Title: ROAD SAFETY ASSESSMENT

Donabate Framework Plan

Client: FINGAL COUNTY COUNCIL.

Report reference: R01

Map of Public Realm Strategy Boundary.

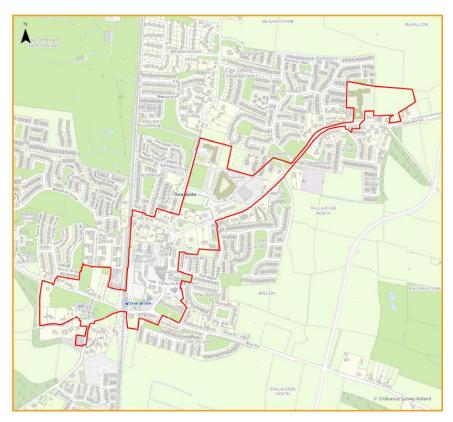
A number of pedestrian crossing facilities are provided along the street however, there are a number of desire lines that do not have formal parallel crossings. There is a deficit of cycle facilities along the street. A high level of car parking is experienced along the Main Street and a lot of the parking is in an irregular pattern, with combinations of parallel, echelon and perpendicular parking along the street and across the footpaths.

The entry speed to the area on most approaches was observed to be high with high volumes of vehicles, cyclists and pedestrians entering the Main Street. The number of cyclists using the route from across the North Fingal area was very evident.

There is considerable interaction between pedestrians and vehicles and vehicle speeds appeared to be high. This was a visual observation only, but it is recommended that a speed survey be conducted to

determine the speed of vehicles travelling through the town from all main entry points particularly Hearse Road at the Bridge, Chapel View/ New Road and Portrane Road.

This survey will determine mitigating measures to be introduced to reduce speeds. Consideration should be given to reducing speed limits across the Main Street and introducing traffic calming measures in the overall plan. This is most notable at the Bridge, Portrane Road and Chapel View.

The intersection junctions at the locations of entry to the town center are too wide, encouraging high speeds at main merge areas. This makes it difficult for pedestrians to make safe crossings at wide junctions.

Map Indicating Key Projects

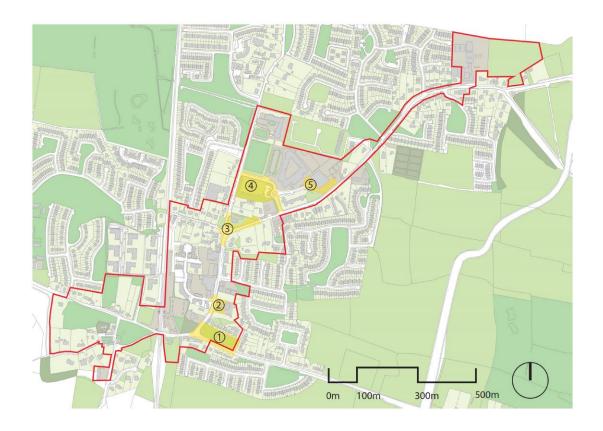
As with the main street the Road Safety Principles apply and can be summarised as follows

- Reduce Speeds by introducing Traffic Calming Measures
- Reduce Carriageway Widths
- Create Pedestrian Links to form continuity with existing Pedestrian Routes
- Standardise crossings and accommodate Desire Lines
- Change Horizontal and Vertical Geometry to make new spaces safer and easy to traverse by all users of these spaces
- Provide good light and drainage
- Provide Clear signage, street marking and lining
- Ensure all street furniture and facilities are designed to cater for safe use and
- Encourage the use of Active Travel

Connecting Spaces Map

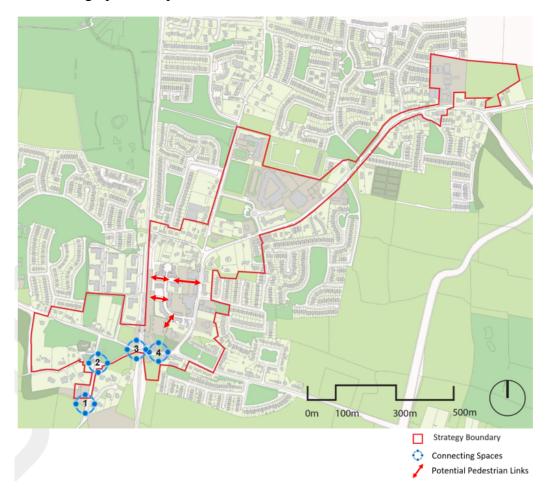
Possible links are identified at Semple Wood and Hearse Road, The Square and Hearse Road, Smyth's Pub, Railway Station and Corballis and Turvey Road, Hearse Road and the Bridge.

The core principles for Road Safety as identified in the Main Street and Key Projects apply with a greater emphasis been placed on lighting, horizontal and vertical alignment, and widths to accommodate all combinations of users.

The framework plan is a great opportunity to provide additional off street car parking by forming new links with existing car parks and the possibility for creating improved parking for the Mobility Impaired, Electric Vehicles, E Scooters and Bicycle Parking Facilities.
